FINAL REMEDIAL ACTION WORK PLAN ADDENDUM

HYDRATED BIOTITE REMOVAL

FORMER W. R. GRACE FACILITY TRACK ACCESS AREA

LIBBY, MONTANA

GRID 9
FIGURE 2

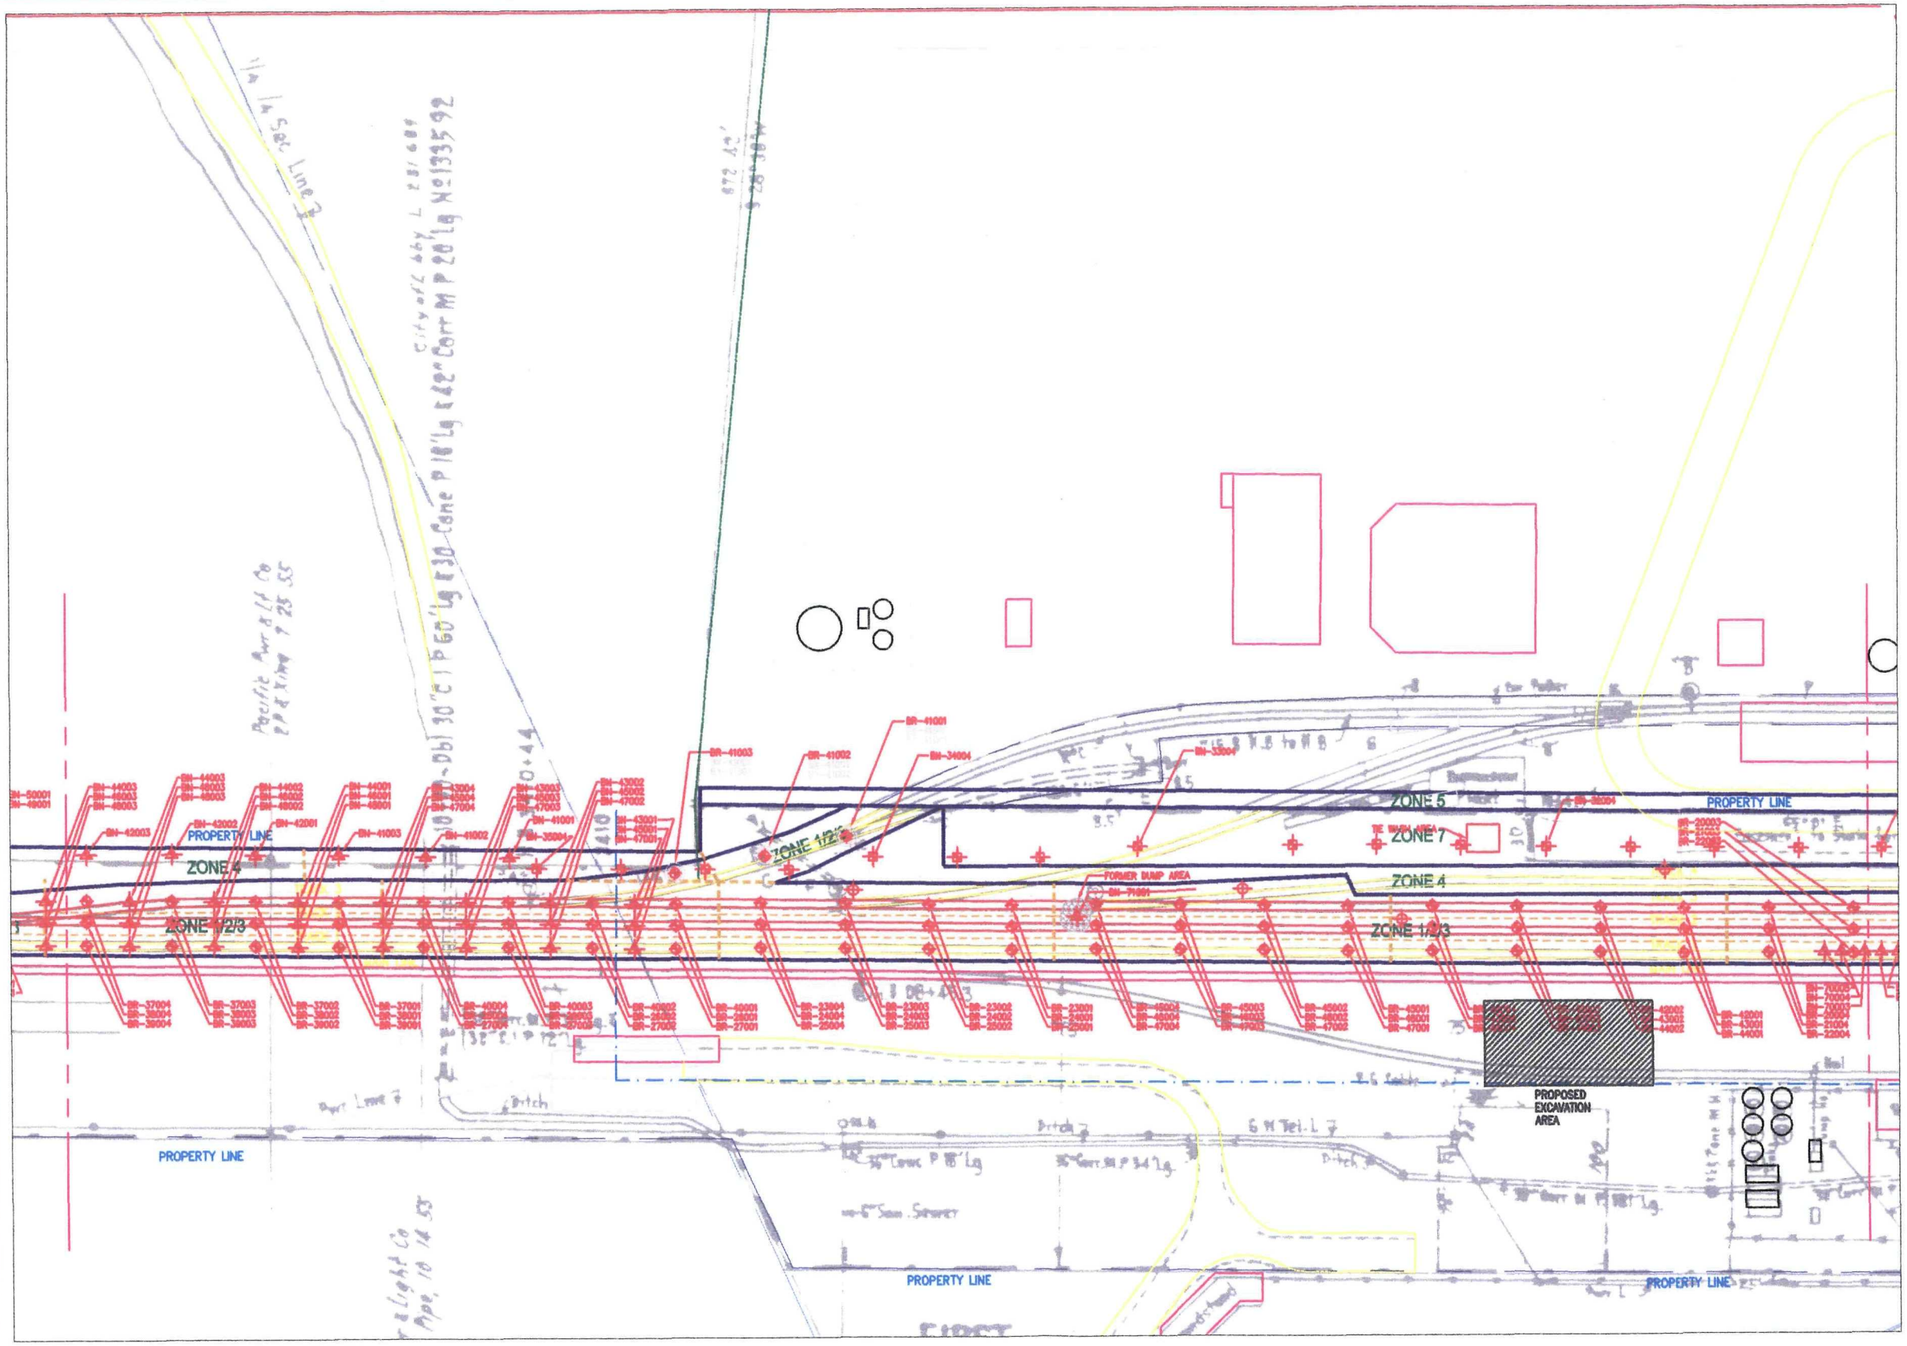
Rails from the spur tracks traversing grids 9 and 20 will be removed from areas depicted in Figures 2 and 3. Removal will include rails, tie plates, spikes, joint bars, bolts, and all other metallic appurtenances. Panels of ties and rail may be pulled in tact if possible. Additional soil samples may be collected in the vicinity of Grid 20, to evaluate whether the frog junction in the grid removal or possible hand digging.

Site soil will be excavated and imported fill placed as shown on Figures 2 and 3. Soil within the south half of Grid 9 and southeast quadrant of Grid 20 will be excavated to remove detectable Libby Amphibole. Soil in Grid 9 and Grid 20 that contain Libby Amphibole will be excavated in accordance with EMR's specifications as identified in Section 2.2.5.1 and the Work Plan.
